**GENWAL MINE  
015/032**

**CHANGE TO THE RECLAMATION PLAN  
FOR THE**

**CRANDALL CANYON MINE MEMORIAL  
and the  
PORTAL WATER DISCHARGE**

**TASK # 2957**

**FIGURE 5-14**

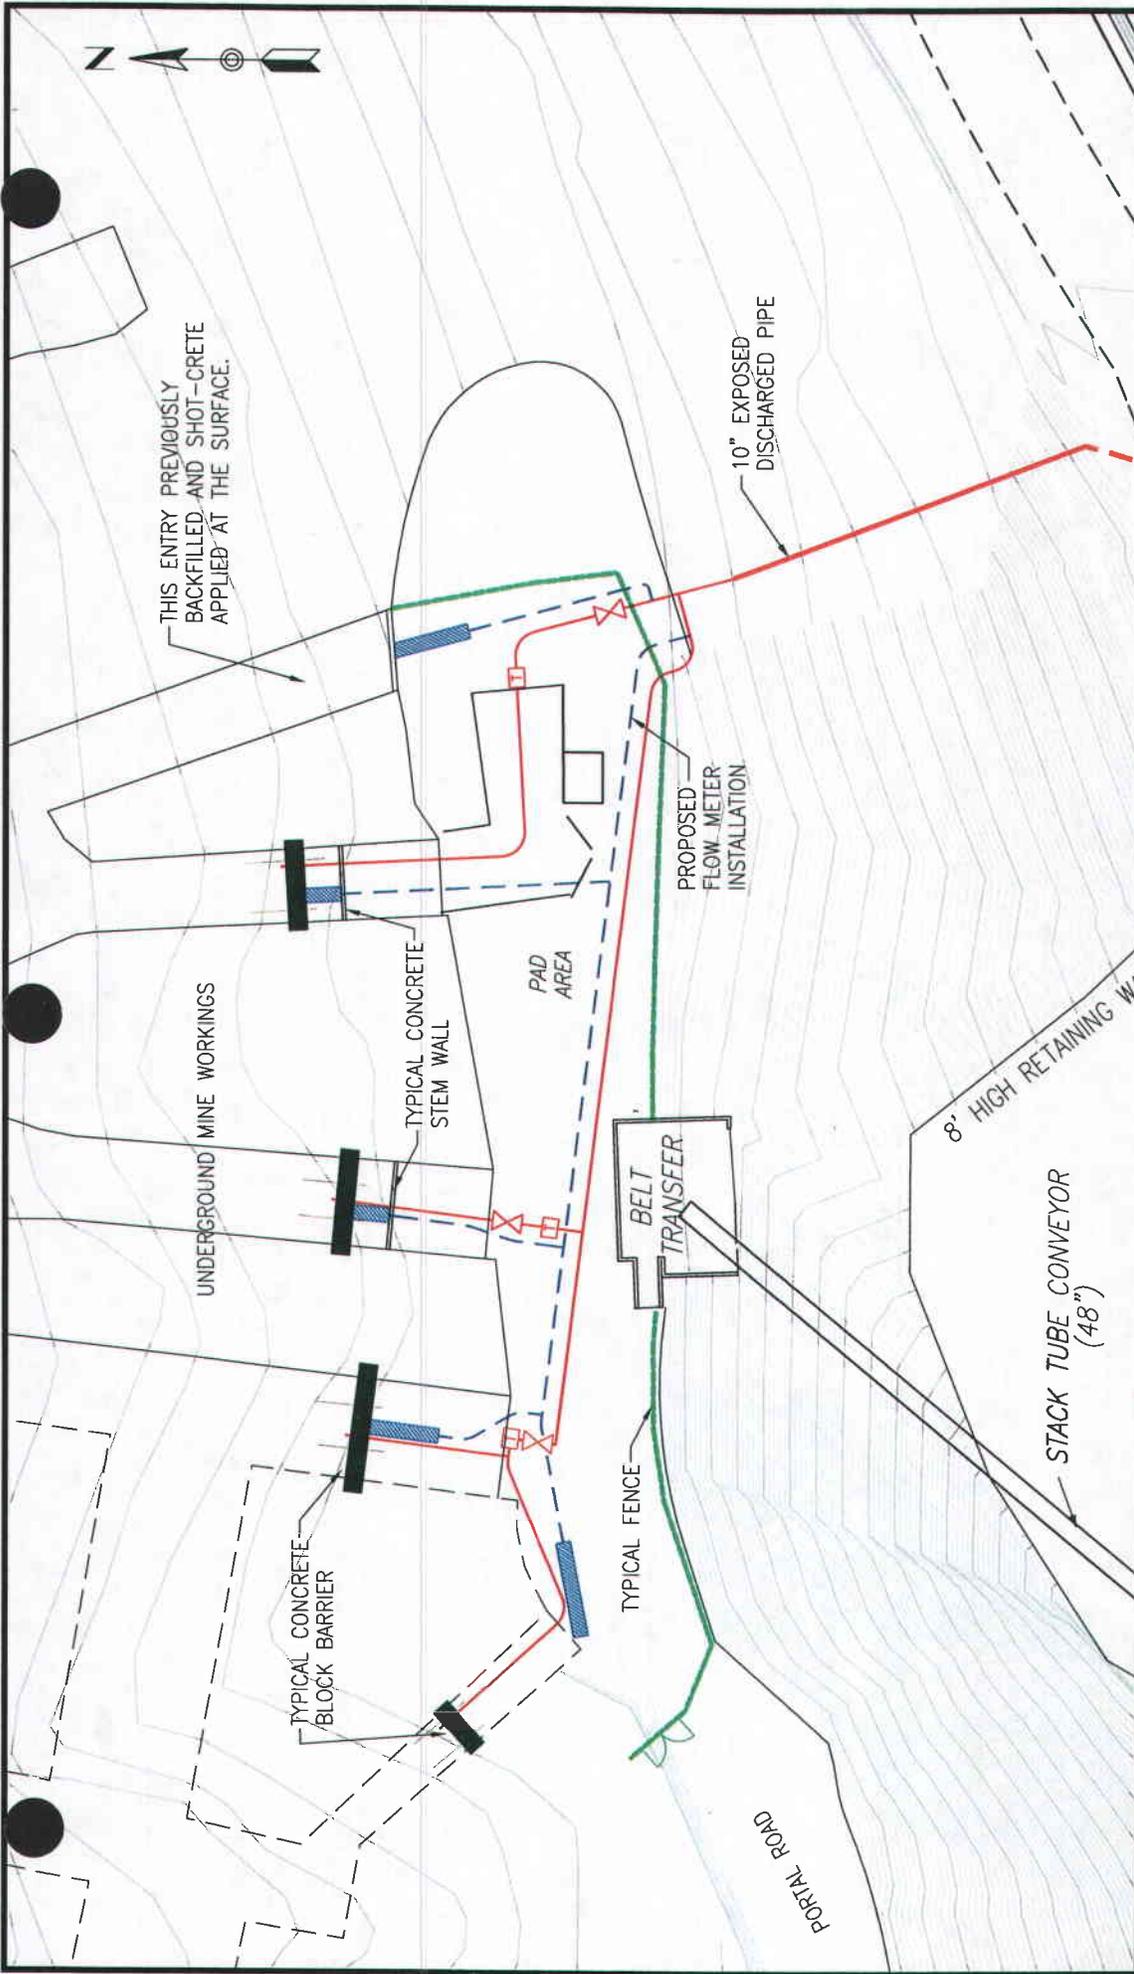
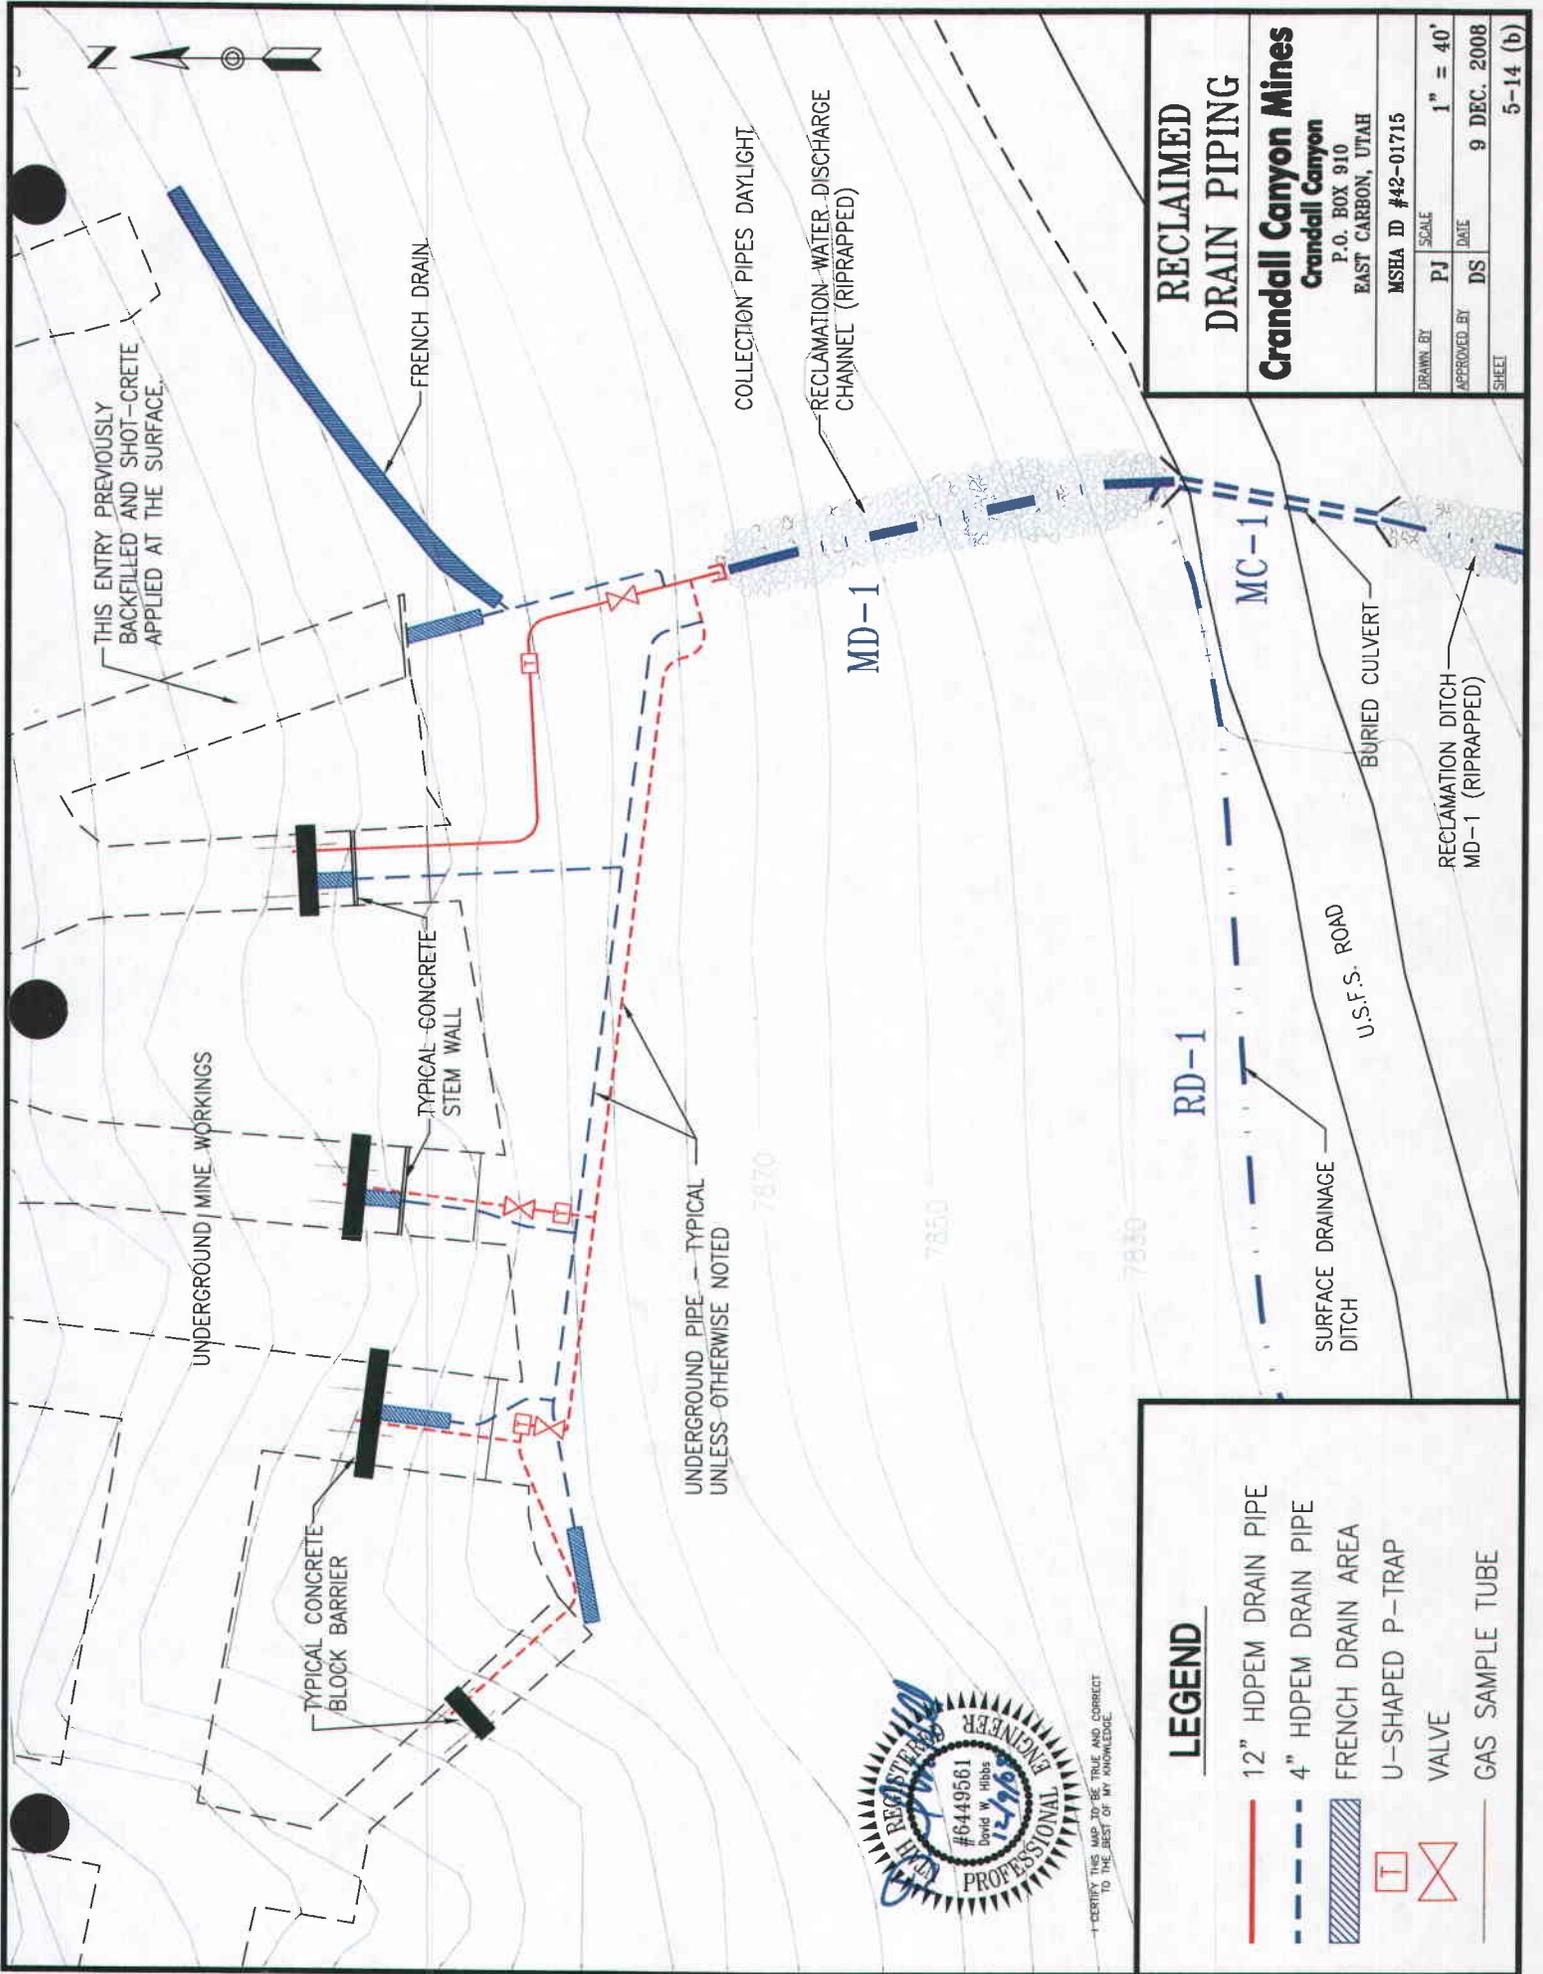
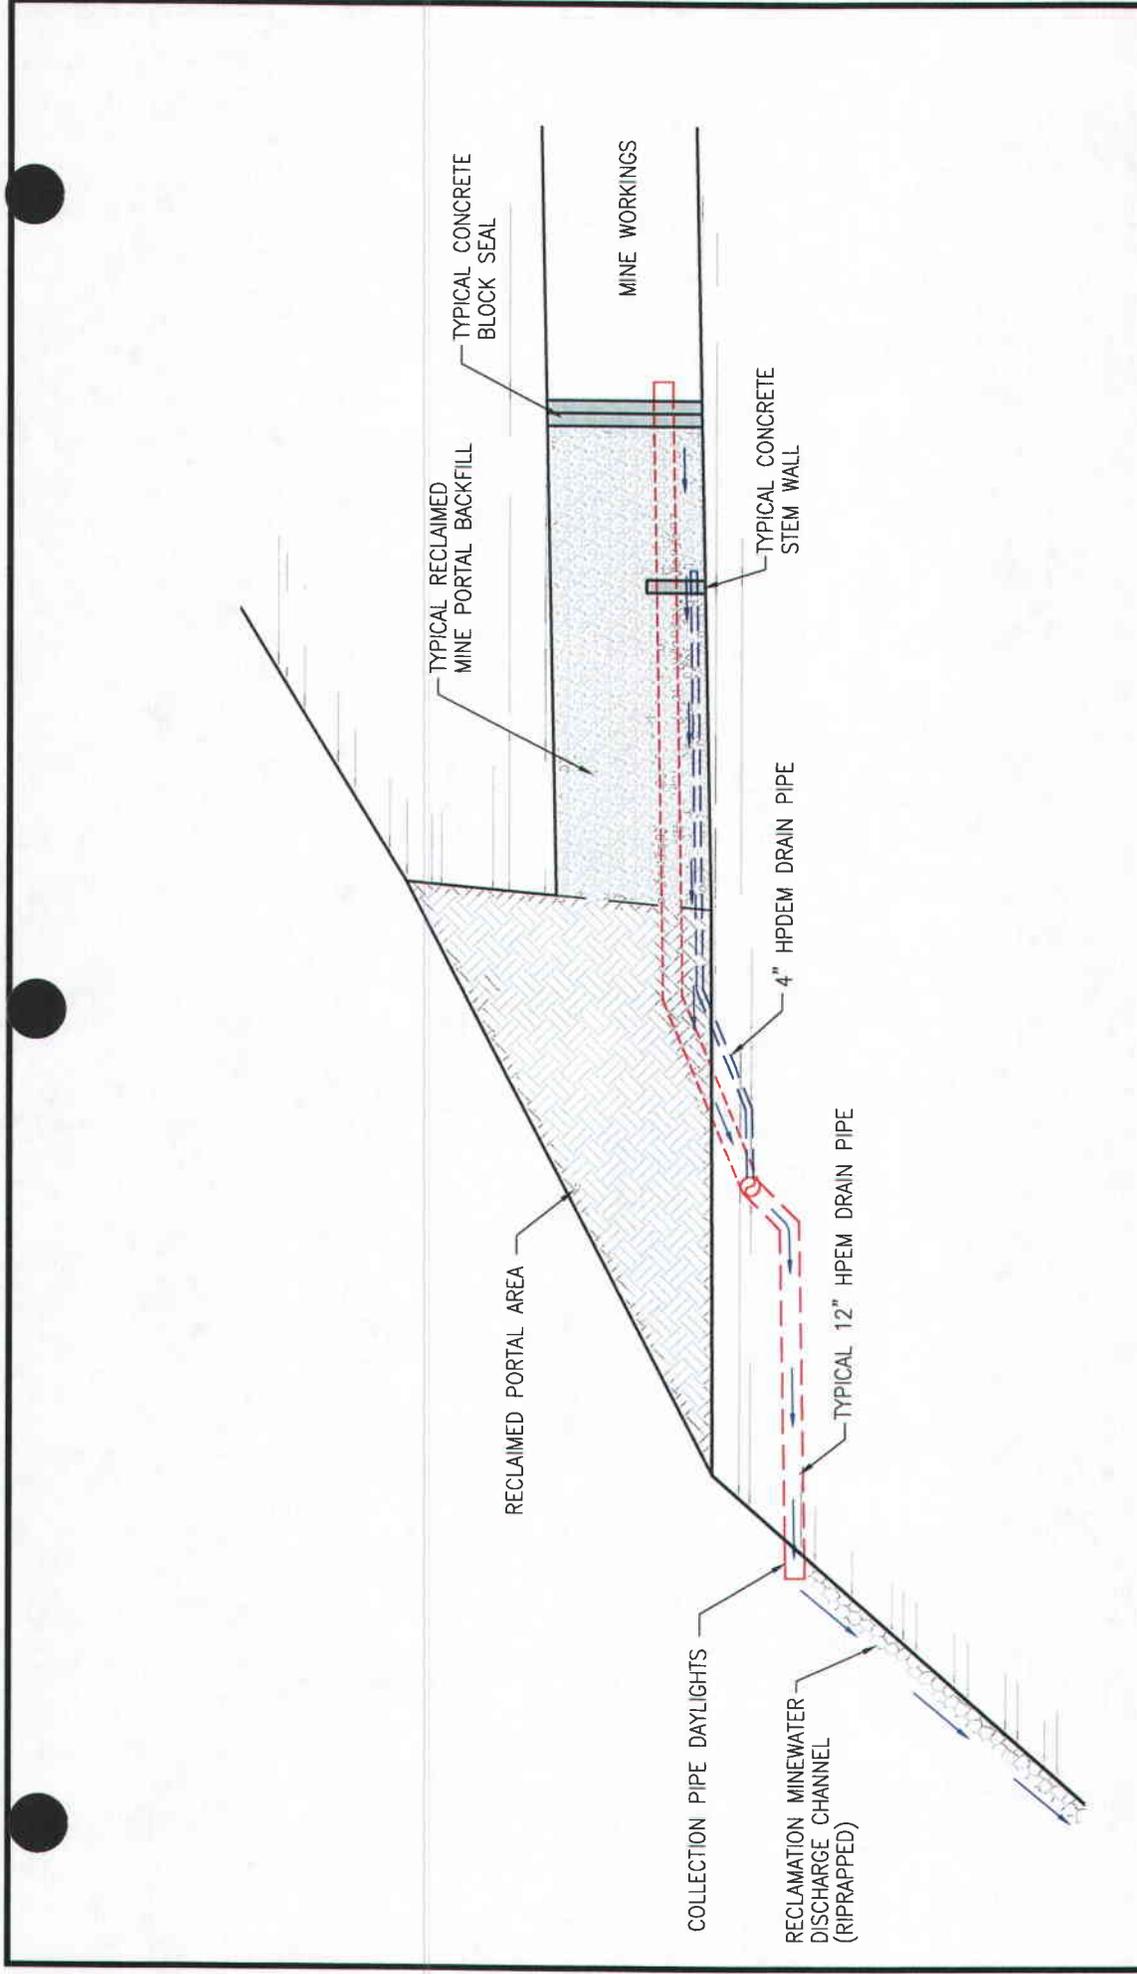
As a result of the Crandall Canyon Mine disaster of August 6, 2007, the portals of the mine were sealed. A system of drainpipes was also installed at the portals to collect and handle the mine discharge water. The mine is presently discharging about 600 gallons per minute, and this volume of discharge is expected to continue indefinitely. Figure 5-14 shows the details of the drain collection system. Presently, water from the four portals is collected into a common pipe which is piped down the hill and discharges into the main bypass culvert at an approved UPDES outfall point. There is also a small amount of water collected in a French drain outside one of the old portals from the old part of the mine (which is sealed off underground), which also reports to the main discharge pipe. All of the collection system is installed either within the portals in by the steel canopies, or else buried along the portal bench. It daylights from the buried installation and continues overland down the hill in an exposed pipe. It should also be noted that some seepage is presently coming from the old (sealed up) works below the existing collection system. This seepage has been ongoing since before the mine disaster, and reports to the sediment pond through a surface culvert. It should also be noted that a small amount of water is infiltrating into the Star Point Sandstone behind the mine seals and is seeping to the surface out of the ledge directly below the portals above the Old Loadout Area.

The reclamation plan acknowledges the water will continue to discharge from the mine (i.e., from the collection pipes, the old works, and the saturated sandstone) on a permanent basis. The company proposes to address the long-term discharge of mine water in the following manner: 1) backfill the portals, leaving the existing collection system in place, 2) construct an additional French drain system to collect the seepage water from the sealed up old works, 3) collect the seepage from the sandstone ledge with a drainrock/drainpipe system, and 4) replace the existing overland discharge pipe with an approved armored open channel. These are discussed individually as follows:

- 1) The existing collection system utilizes 10" heavy-wall PVC pipe extending back through the seals in all four portals. Additional 4" pipes also collect seepage water outside the seals which is entrapped behind specially constructed check dams. All piping is buried and was installed with plans to be part of the permanent post-reclamation discharge system. Upon reclamation, after the steel canopies have been removed, the portals will be completely backfilled as described below, leaving only the stub of pipe exiting to the surface at its present location. Figure 5-14 shows details of the existing pipe collection system.

- 2) A French drain is presently installed at the old portal of the old sealed works. However, because the old works are so close to the outcrop (in the area immediately east of the fan portal) there is a small but continuous seep of water along this area. Upon reclamation, the existing French drain will be extended eastward to pick up the additional water which is seeping to the outcrop. This seepage water will be routed into the main collection pipe prior to final discharge.

- 3) Under final reclamation the sandstone ledge below the portals (a.k.a. Old Loadout Area)

will be backfilled to approximate original contour as described in item 13 below. As explained above, due to the porous nature of this sandstone, it is now conveying a small but constant amount of mine water from behind the seals to the ledge outcrop below the portals. The seepage conduit is localized and can easily be contained during final reclamation. This will be done by installing a drain system between the ledge-rock and the backfilled slope which will collect the seepage water into a single discharge pipe. This will then be directed to join the main stream of discharge, so that all discharge enters into Crandall Creek at a common point. The details of this collection system are explained in item 13 (Old Loadout Area) below.

4) Presently, the discharge water is conveyed down from the portals down over the hill through a 12" PVC pipeline. This line then empties into an existing CMP culvert which leads to the main bypass culvert at an approved UPDES monitoring point. Upon final reclamation the PVC pipe would be replaced with an overland channel. In this area the sandstone bedrock lies very close to the surface, and forms natural outcrop ledges in the immediate and surrounding area. With a minor amount of work debris and weathered material can be removed to expose the competent bedrock below and thereby create a permanent, non-erosive channel for the discharge water course. In those areas where the weathered material is thicker, such as below the Forest Service Road (which will remain in place after mine reclamation) the channel would be lined with a suitable rip-rap. There would be no other flow in this channel other than the continuous 600 gpm mine discharge.
